BULLETIN.005

WELDARC 150: MC84 TIGARC 140: MC86 MC84 AND 86-11 RESISTOR VALUES

WELDING INDUSTRIES OF AUSTRALIA	
				112 Daws Road, Melrose Park, S.A.5039	
				TITLE	
				P.C.BOARD ASSEMBLY	
B.	10/7/90	ec	RESISTOR VALUES R8 & R9 CHANGED C/N 1054	DRAWN	DRAWING No.
A			ISSUE FOR MANUFACTURE	M.W.	
ISSUE	DATE	CHKD.	REVISION	DATE	
				6-7-90	MC84-11

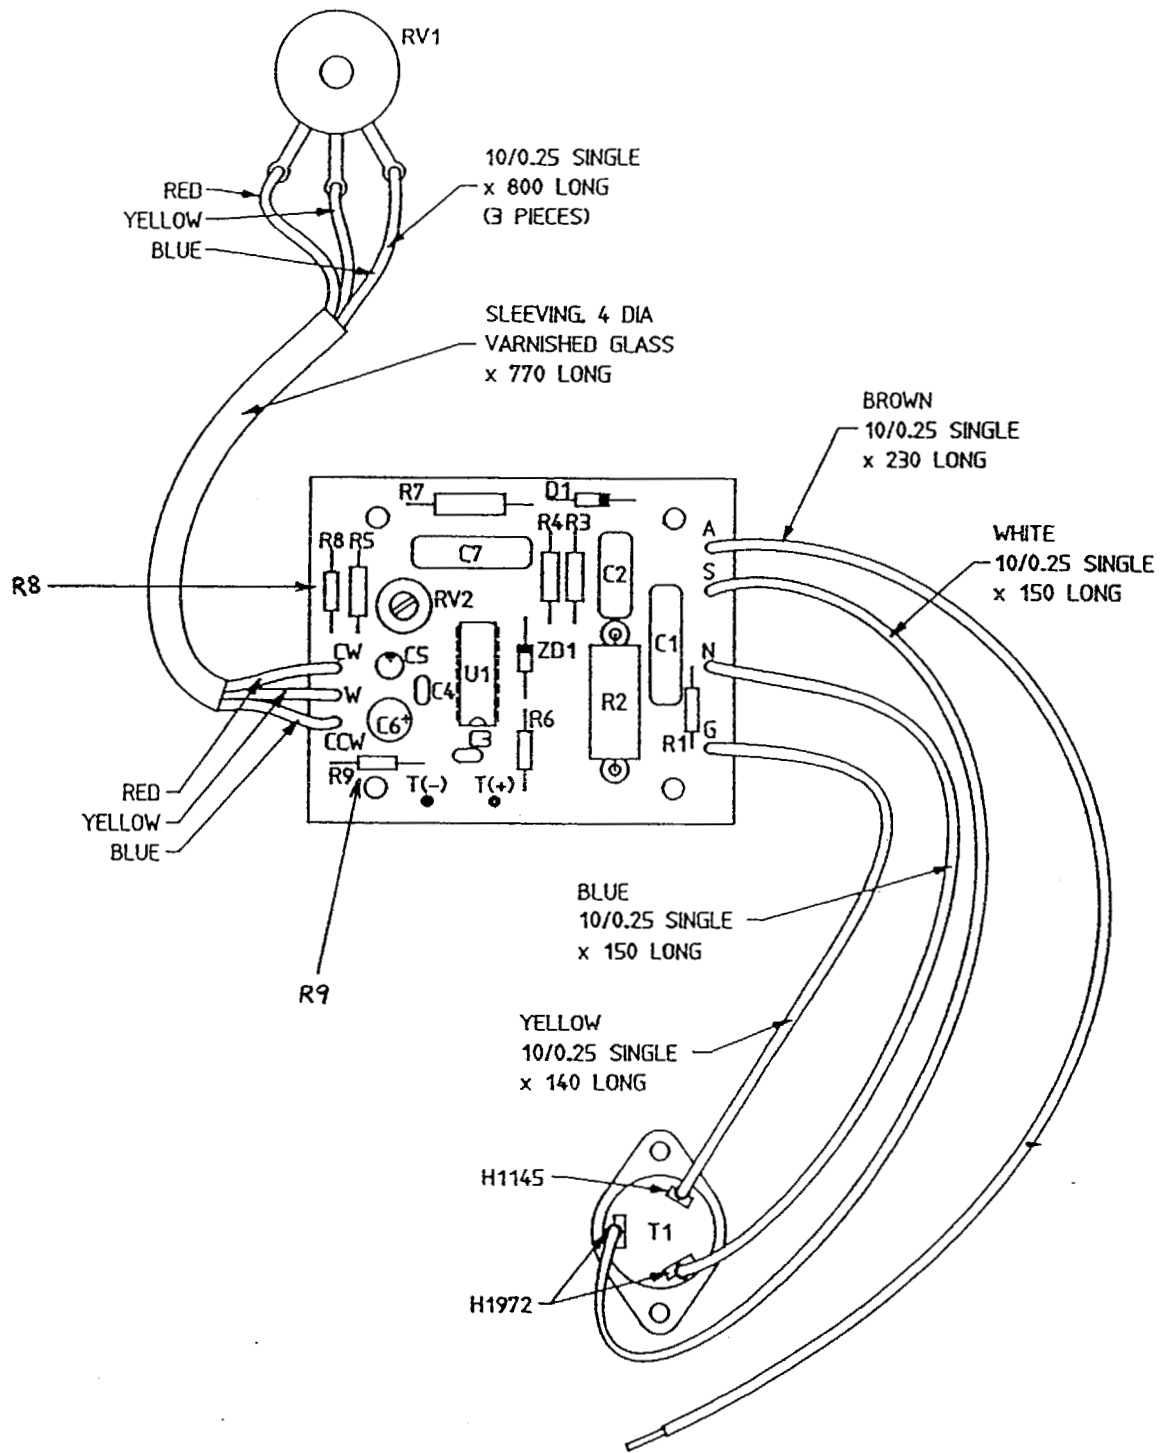
On the MC84-11 PCB's, the values of the resistors R8 and R9 have now been changed:

R8 resistor was 27K ohms, is now 22K ohms.
R9 resistor was 18K ohms, is now 15K ohms.
